ENGINEERING CHANGE NOTICE

1. ECN 187883

Proj. ECN B-714-136

3. Originator's Name, Organization, MSIN, and Telephone No. T. E. Coyne, KEH, E6-42, 6-2564			4. Date 07-24-92	
5. Project Title/No./Work Order No. GRouted WASTE DISPOSAL FACILITIES B-714/ER8007		6. Bldg./Sys./Fac. No. 218-E-16		7. Impact Level 3Q /SC-2

Ref. Dwg. H-2-77645	Sh. 1	Rev. 1	Prepared By TE COYNE	Checked By <i>A.R. [Signature]</i>	ECN No. B-714-136	Page 4/9
------------------------	----------	-----------	-------------------------	---------------------------------------	----------------------	-------------

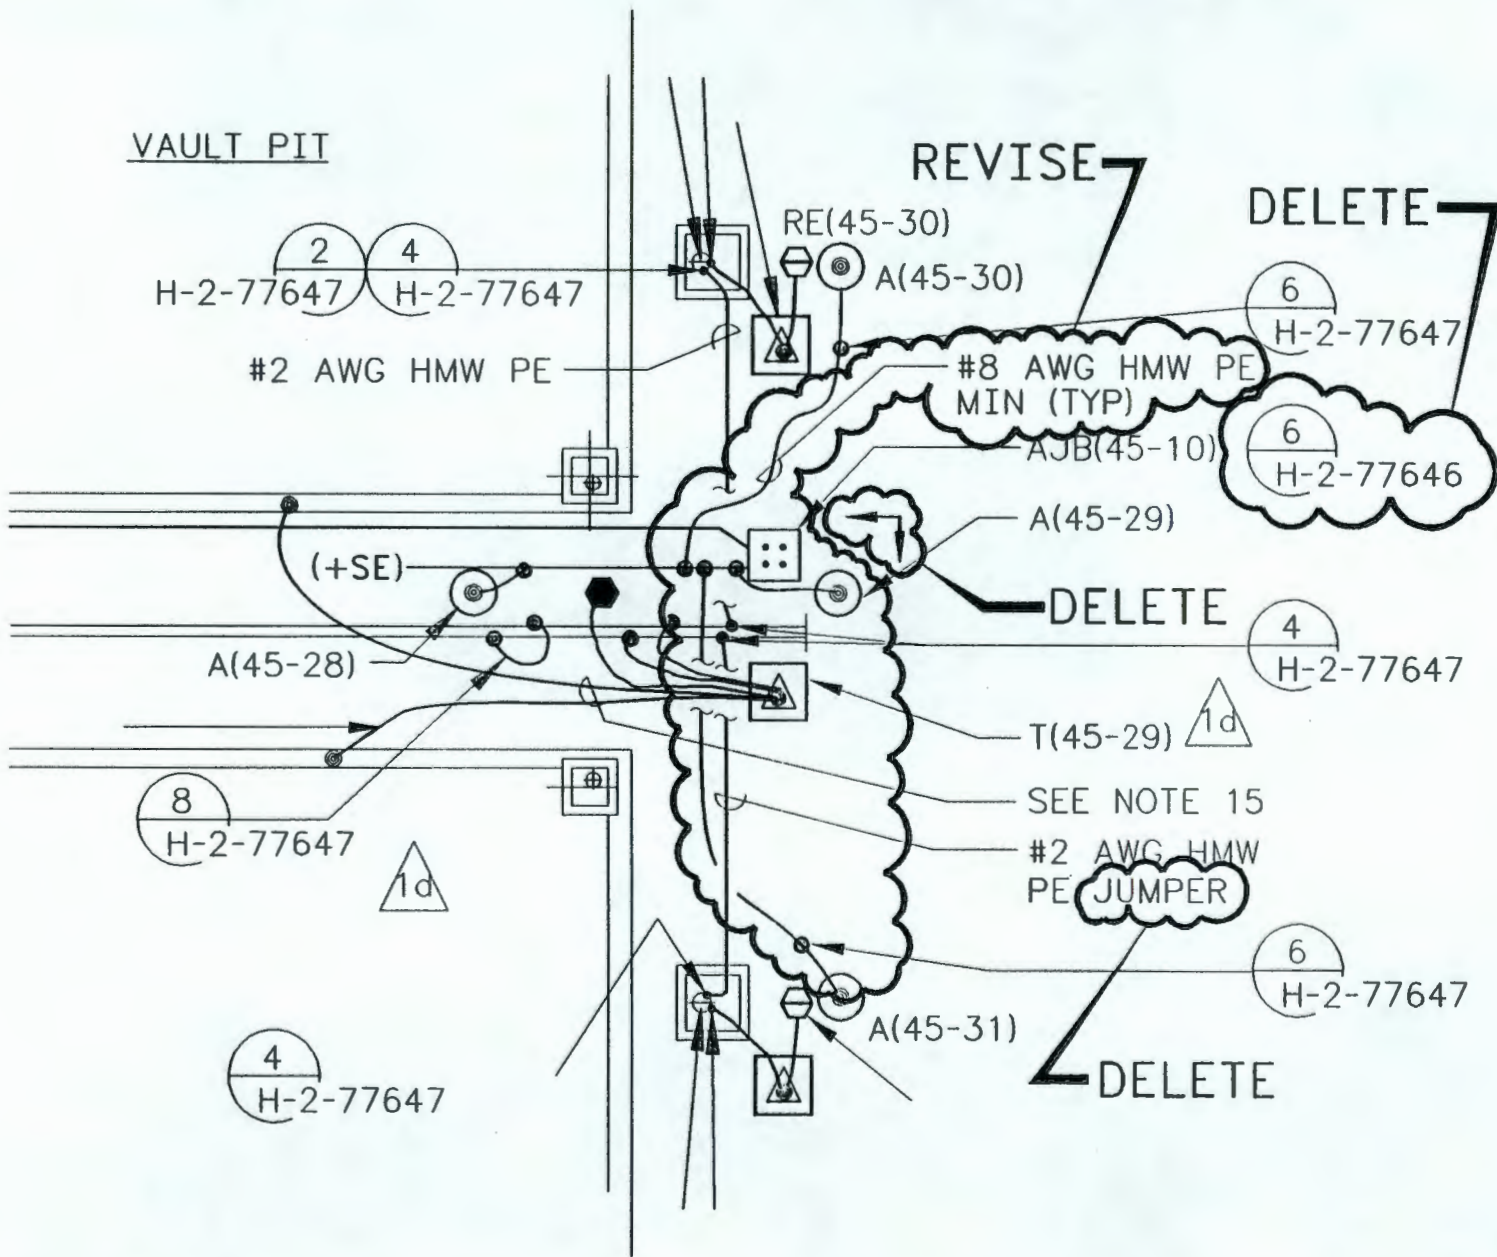
- 1) H-2-77645, Sh 1, Rev 1
 A) Zn D5: Delete the Detail 6 bubble in its entirety including the leaderline to AJB(45-9).
 B) Plan (Zn C-D3): Revise as shown on page 4 of this ECN.

Ref. Dwg. H-2-78511	Sh. 1	Rev. 1	Prepared By TE COYNE	Checked By <i>E. R. ...</i>	ECN No. B-714-136	Page 6/9
------------------------	----------	-----------	-------------------------	--------------------------------	----------------------	-------------

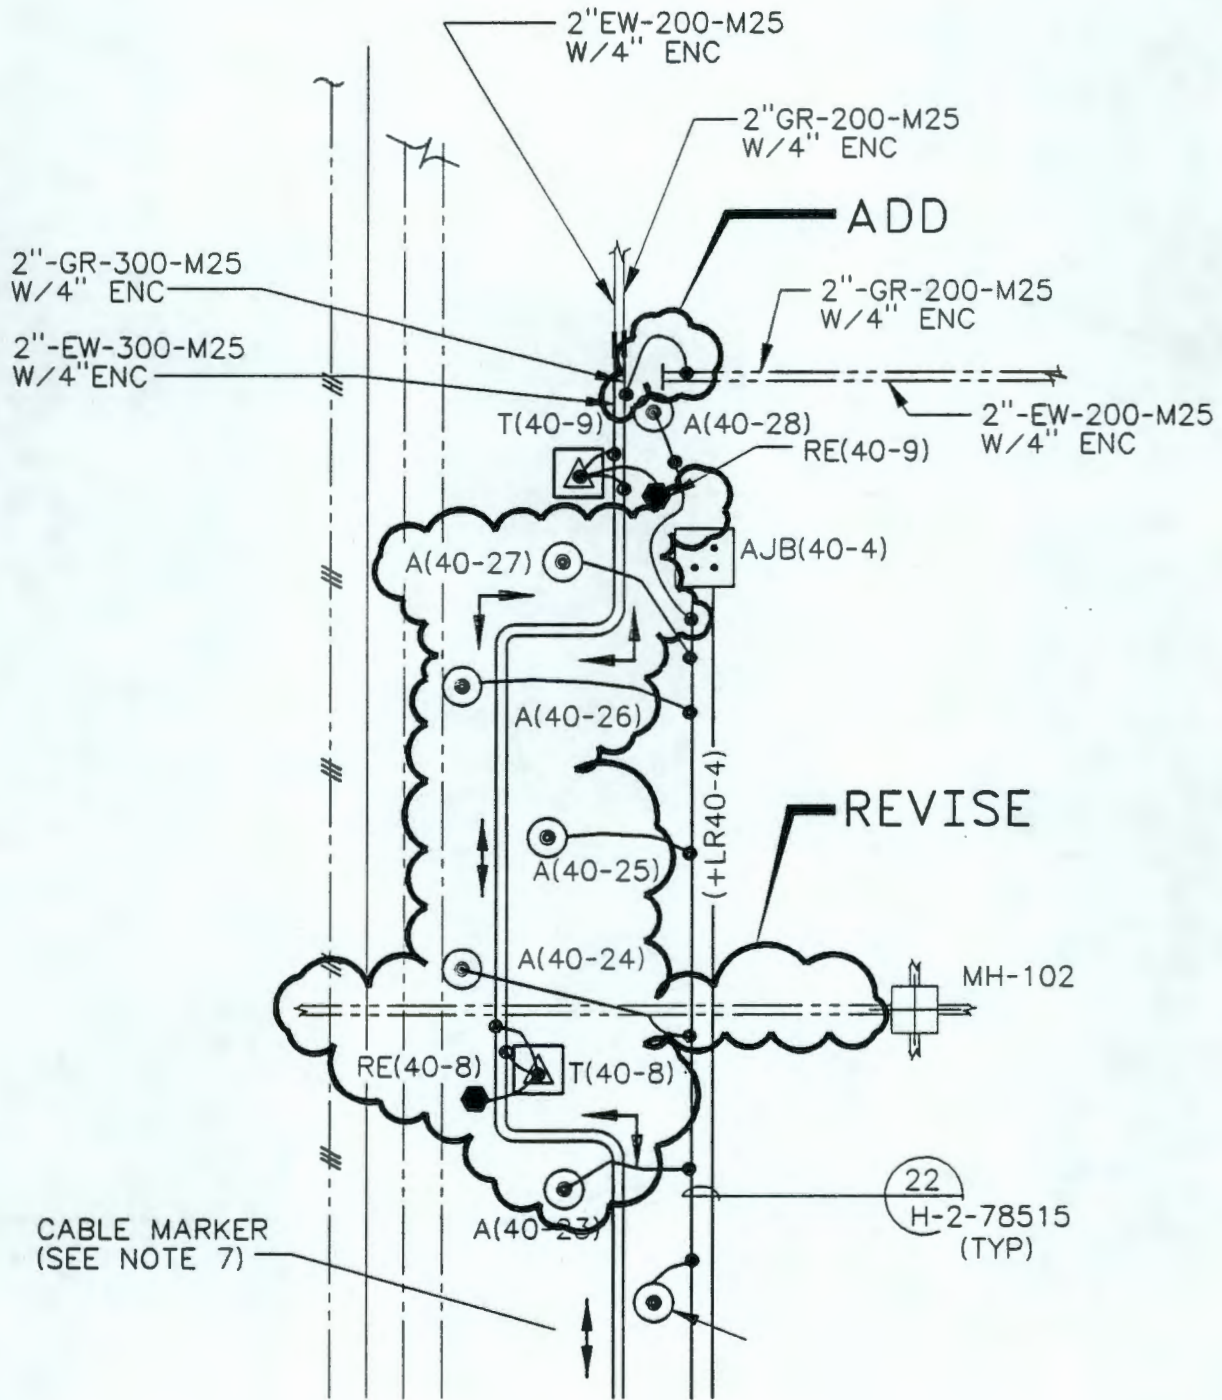
- 4) H-2-77648, Sh 1, Rev 0
 Detail 6 (Zn E1-F3): Replace with new Detail 6 as shown on page 9 of this ECN.
- 5) H-2-78511, Sh 1, Rev 1
 A) Plan (Zn D7-E7 & D4): Revise as shown on page 5 & 6 of this ECN.

Ref. Dwg. H-2-78511	Sh. 1	Rev. 1	Prepared By TE COYNE	Checked By <i>E. R. [Signature]</i>	ECN No. B-714-136	Page 7/9
------------------------	----------	-----------	-------------------------	--	----------------------	-------------

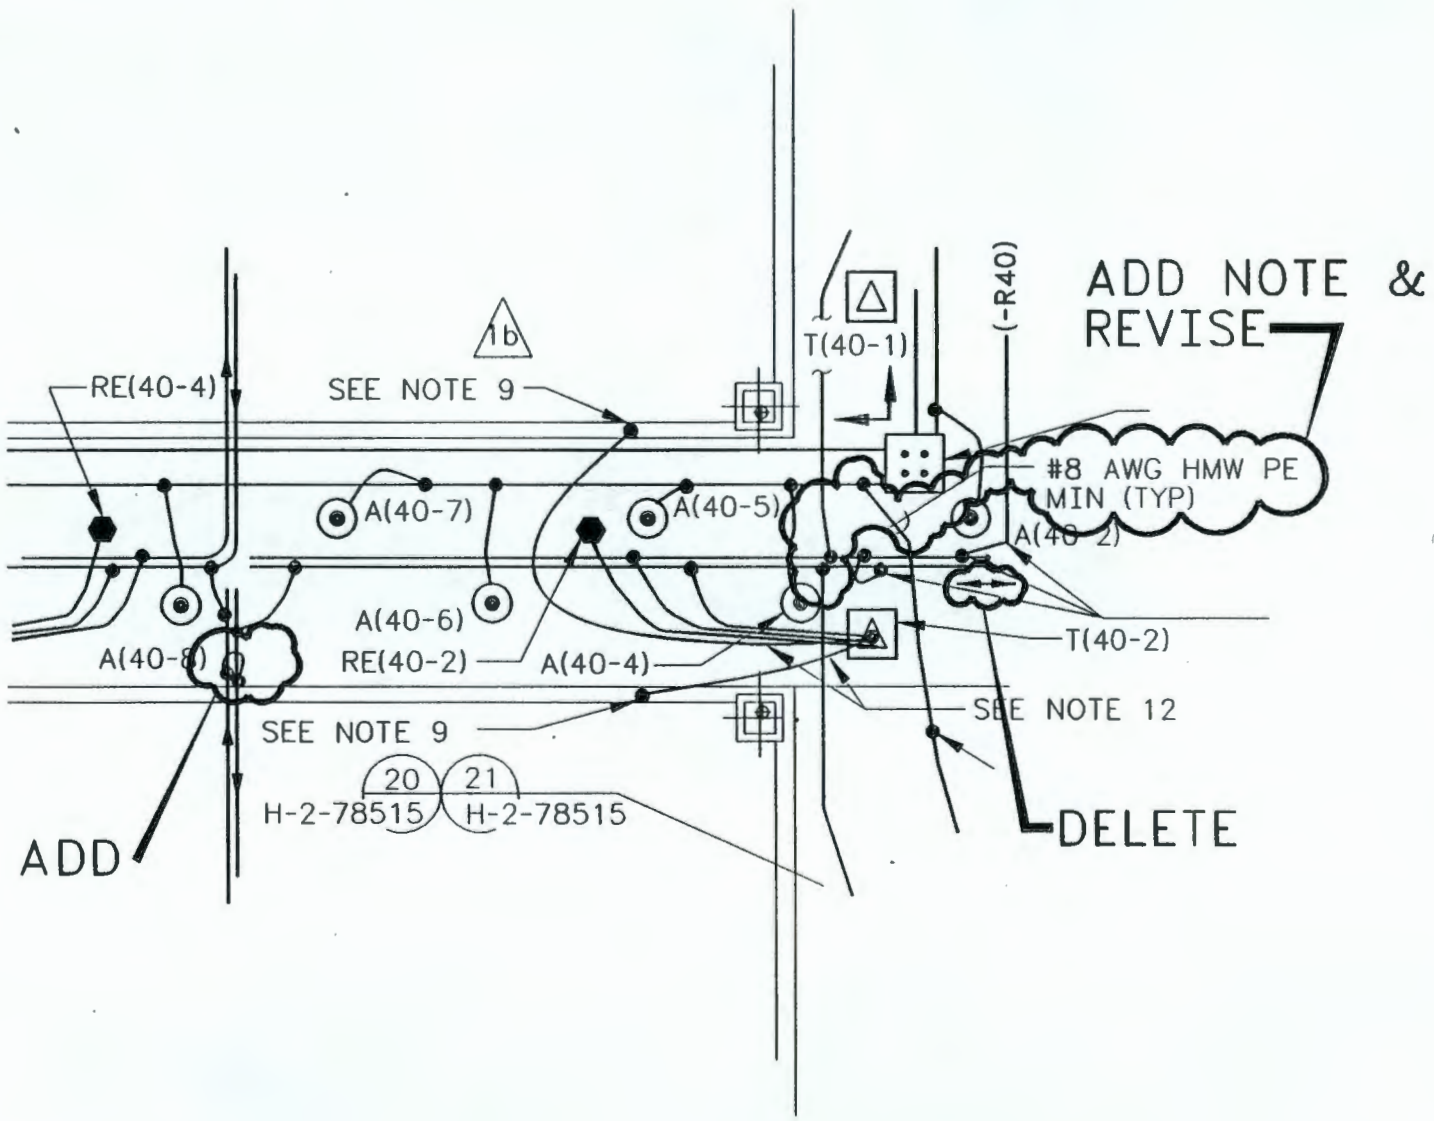
B) Anode Location Table: Revise the coordinates for the anodes listed on page 7 of this ECN.
 C) Test Station Location Table: Change the coordinate for T(40-8) from W45773 to W45777.

ANODE LOCATION TABLE (SEE NOTE 5)		
NUMBER	COORDINATES	
A(40-2)	N40271	
A(40-5)	N40271	
A(40-7)	N40271	
A(40-9)	N40271	
A(40-11)	N40271	
A(40-13)	N40271	
A(40-15)	N40271	
A(40-17)	N40271	
A(40-20)		W45762
A(40-22)		W45762
A(40-23)	N40346	W45775
A(40-24)	N40375	W45789
A(40-25)		W45777
A(40-26)		W45789
A(40-28)	N40444	W45762

DETAIL
VERTICALLY
INSTALLED ANODE

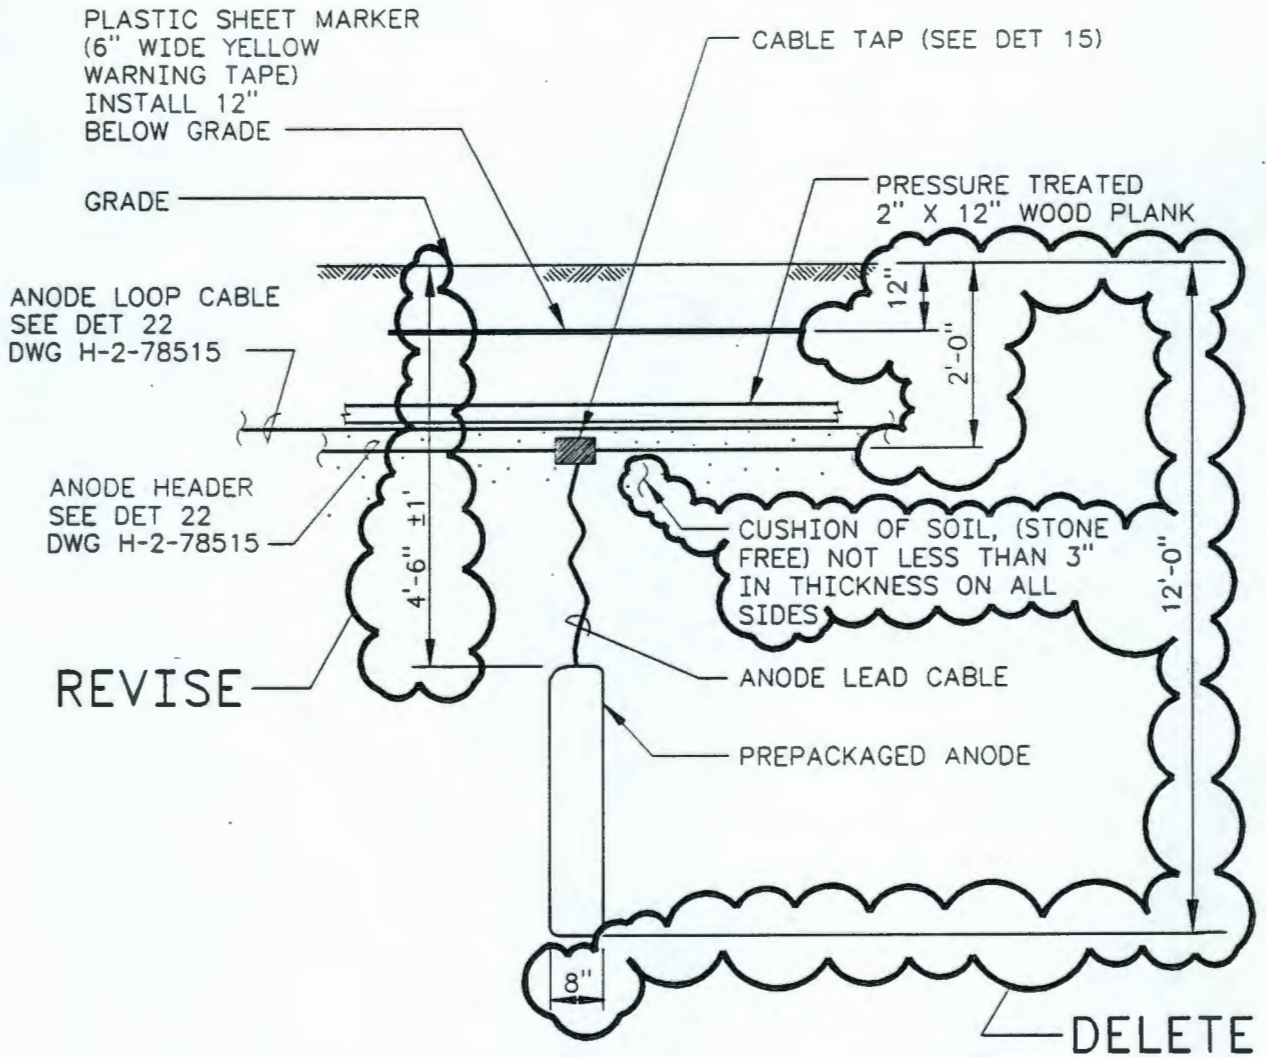
- 6) H-2-78514, Sh 1, Rev 0
 Detail 13 (Zn E6-F8): Revise Detail 13 as shown on page 8 of this ECN.
- 7) H-2-78515, Sh 1, Rev 0
 Detail 22 (Zn C7-D8): Replace with new Detail 22 as shown on page 9 of this ECN.
